Technical Service Information

THM 440-T4 / 4T60-E BOTTOM PAN OIL FILTER CHANGES

Figure 1

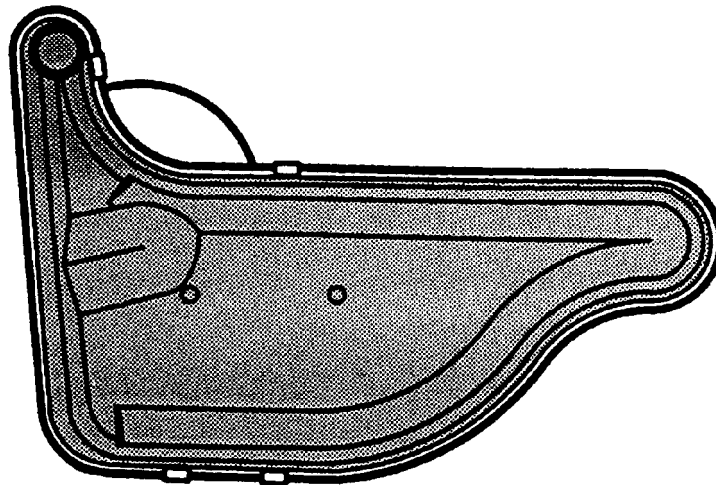
COMPLAINT: Some 1993 and 1994 L, N, and W Cars (See Models Below), equipped with a THM 4T60-E transaxle with the structural (Cast Aluminum) side cover may exhibit a fluid leak between the structural side cover and transaxle case. The transaxle case **MUST** be identified with die number 723, as shown in Figure 1.

CORRECTION: Replace the original molded steel side cover gasket with a new replacement gasket service package, available under OEM part number 8651940. This new service package should be used **ONLY** on 93-94 THM 4T60-E transaxles that have case I.D. 723, use a structural side cover, and exhibit a side cover leak.

Figure 2

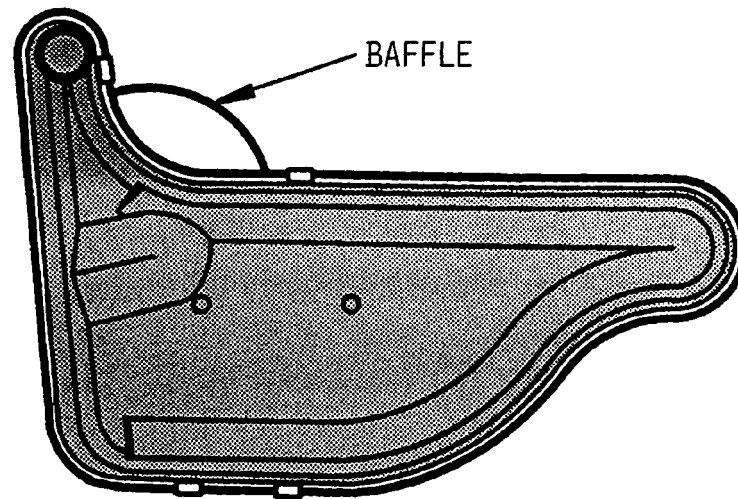
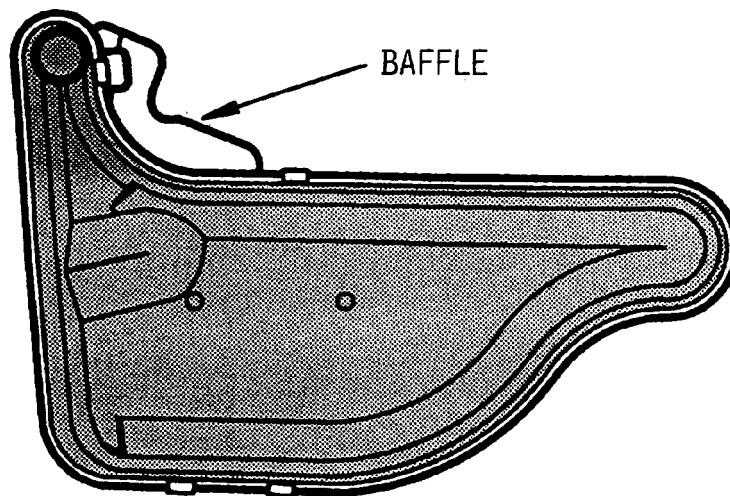
CAUSE: Casting change implemented on case die I.D. 723, which reduced the thickness of a section of case wall affecting the gaskets sealing ability, when used with a structural side cover (See Figure 2).

THM 4T60 AND 4T60-E TRANSAXLE OIL FILTERS WILL NOT INTERCHANGE!
